Q-340

SVE BULLETIN

EVAPORATIVE EMISSION SYSTEM, FRESH AIR LINE MOVEMENT DURING VEHICLE UPFIT

Dual Canister (55-gal fuel tank) on 158” wheelbase

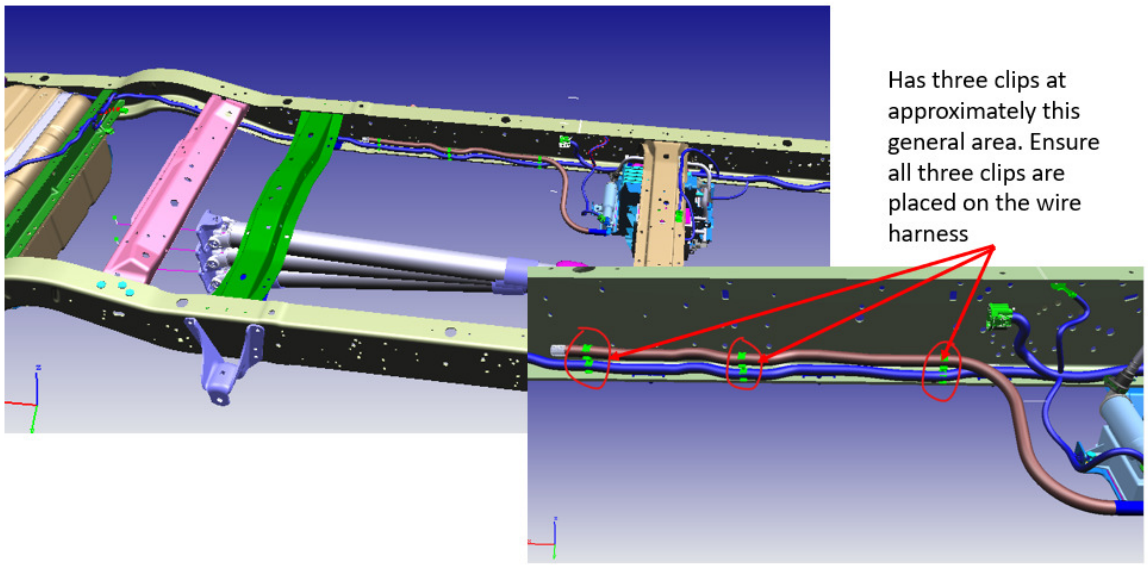
Warranty reports have been received relating to the fresh air line being contaminated due to improper retention/placement during vehicle upfits. The following diagrams should be used to ensure the proper placement and retention of the Evaporator emission system fresh air line.
While the positions may not be exact, the general location should be close.
Fresh air line should not be hanging off the vehicle near the end.
Clips should not be damaged

Dual Canister (55-gal fuel tank) on 176” wheelbase

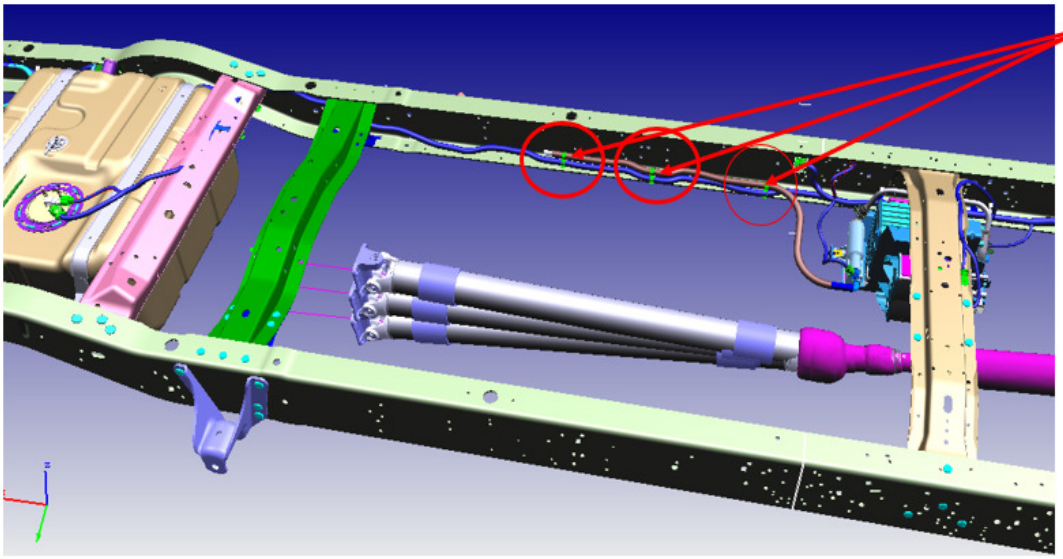
Has three clips at approximately this general area. Ensure all three clips are placed on the wire harness

Single Canister (40-gal fuel tank) on 138” wheelbase

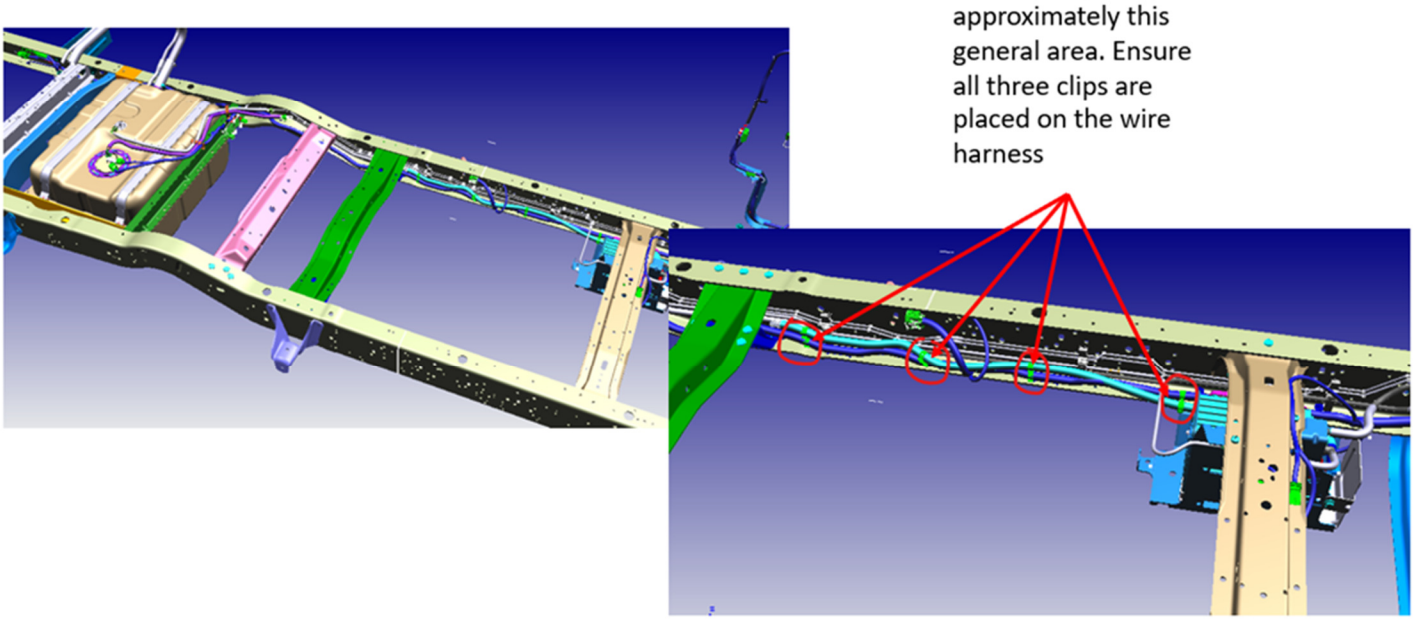
Has four clips at approximately this general area. Ensure all three clips are placed on the wire harness
